Service Info

Visual differences

in over-running alternator pulley 535 0241 10

Part no.: 535 0241 10

Figure 1: Previous design

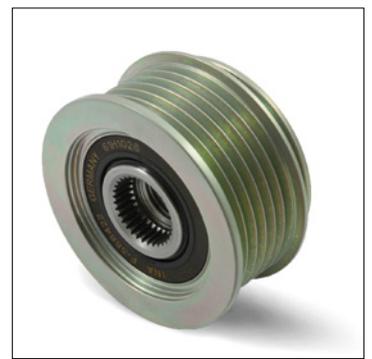
As part of our continuous efforts to improve our products, modifications have been made to the over-running alternator pulley with part number 535 0241 10.

This Service Information sheet shows the visual features of the previous version (Figure 1) and the new version (Figure 2).

The two versions differ only in their appearance. Both comply with the technical specifications and can be used without restrictions.
